Access Compliance Report

Public Rights-of-Way

Intersection ID: 25988	Main Street: BLUE_HERON_DR	Cross Street: NIGHTINGALE_LN	Location: NW
ADA ID: 2F8F29781758	Ramp Type: Directional1	Initial Pass/Fail: Fail	Overall Compliance: No
		Severity Score: 12.5

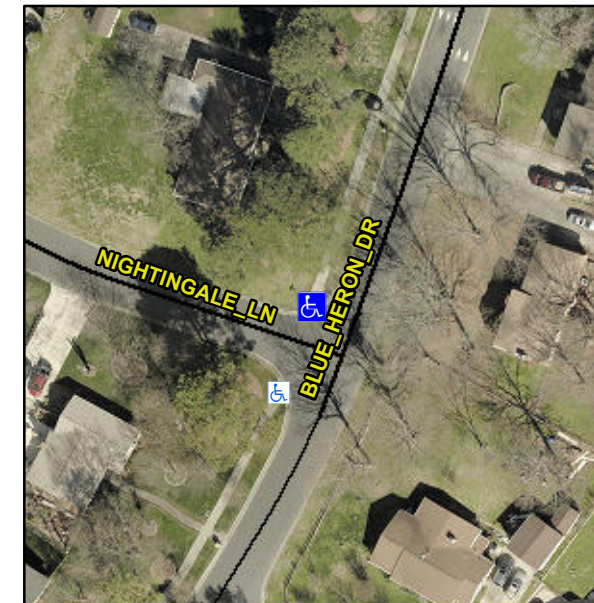
R304.2.2

Compliance	Description	Data	Compliance	Description	Data
N/A	Ramp Length (in)	138.0	N/A	Grade Break?	N/A
Yes	Ramp Width (in)	58.0	N/A	Grade Break Slope (%)	0.0
No	Ramp Slope (%)	10.8	N/A	Grade Break XSlope (%)	0.0
Yes	Ramp XSlope (%)	1.0			
N/A	Flare Type LT	N/A	N/A	Flare Type RT	N/A
N/A	Flare Slope LT (%)	N/A	N/A	Flare Slope RT (%)	0.0
N/A	Flare Traversable LT?	N/A	N/A	Flare Traversable RT?	N/A
N/A	Landing Length (in)	0.0	N/A	DWS Provided?	N/A
N/A	Landing Width (in)	0.0	N/A	DWS Contrast?	N/A
N/A	Landing Slope (%)	0.0	N/A	DWS Length (in)	N/A
N/A	Landing X Slope (%)	0.0	N/A	DWS Full Width?	N/A
N/A	Landing Curb? (Y/N)	N/A	N/A	DWS Offset LT (in)	N/A
N/A	Shared Landing?	N/A	N/A	DWS Offset RT (in)	N/A
N/A	Gutter Ponding?	0.0	N/A	Gutter Slope (%)	N/A
N/A	Gutter Lip Ht (in)	0.0	N/A	Gutter X Slope (%)	N/A
N/A	Painted X Walk1?	No		Road Slope (%)	1.6
	X Walk 1 Direction	To S		Road X Slope (%)	6.5
	X Walk 1 Width (in)	N/A		Clear Space?	N/A

Remove & Replace Entire Ramp.
